## FACSIMILE MEMORANDUM SHEET

**Subject:** Kawahara Nursery, San Lorenzo

Subject: Investigations at Kawahara Nursery located at 16550 Ashland Ave., San Lorenzo CA

**SITE PLAN**  
**KAWAHARA NURSERY**  
**SAN LORENZO, CA**

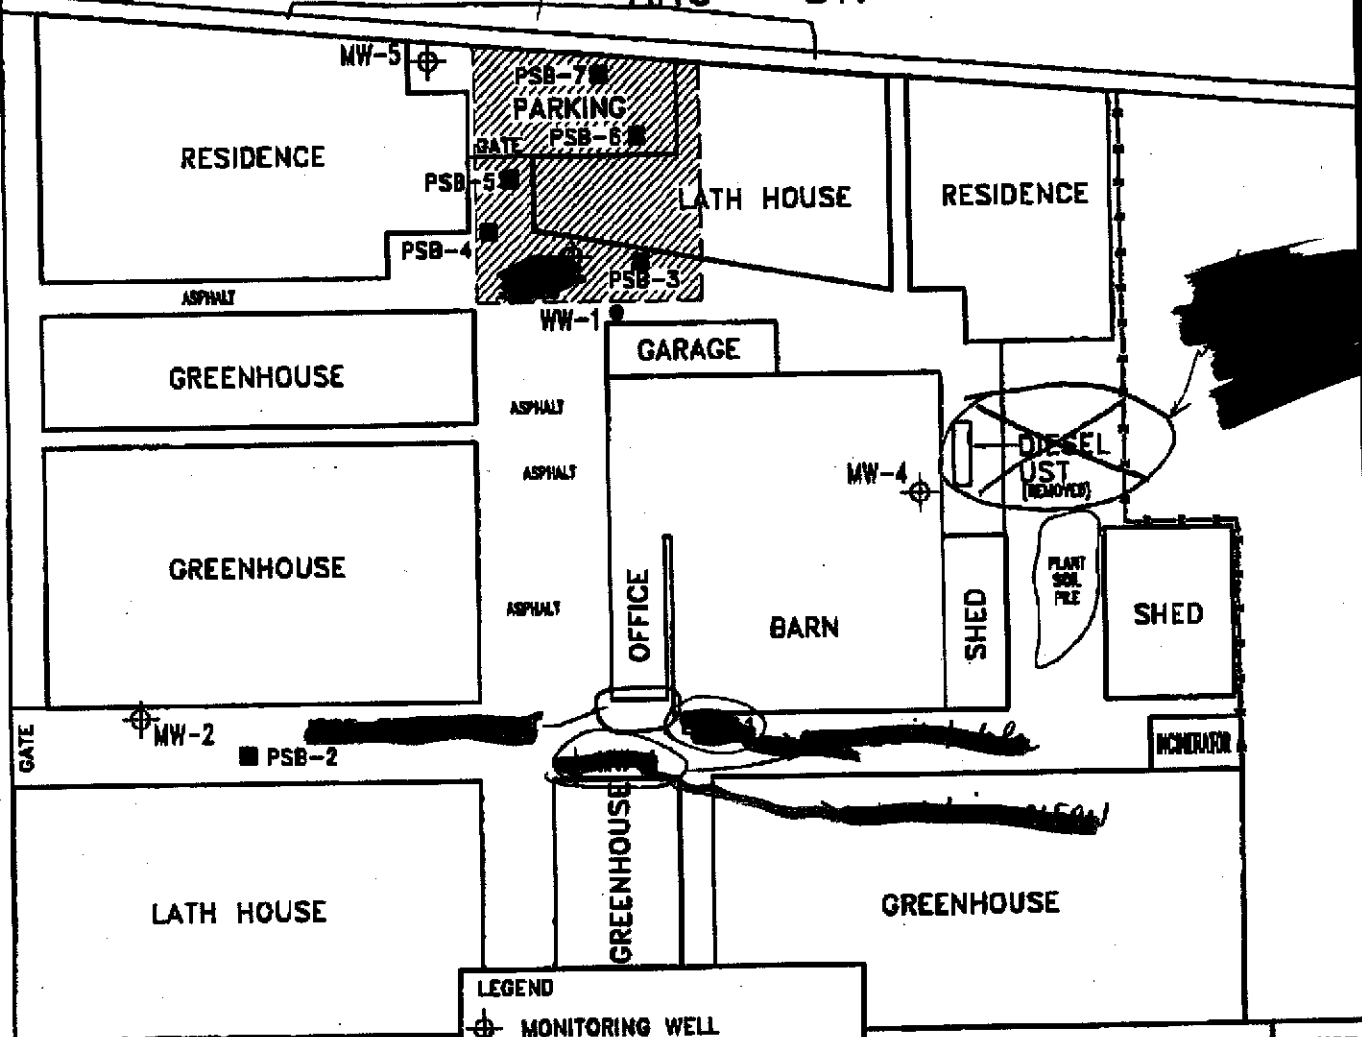
1) There is only one KNOWN former UST location (near MW-1). The diesel UST was removed and stored above ground next to the barn. The UST is no longer stored there, ~~see map accordingly.~~
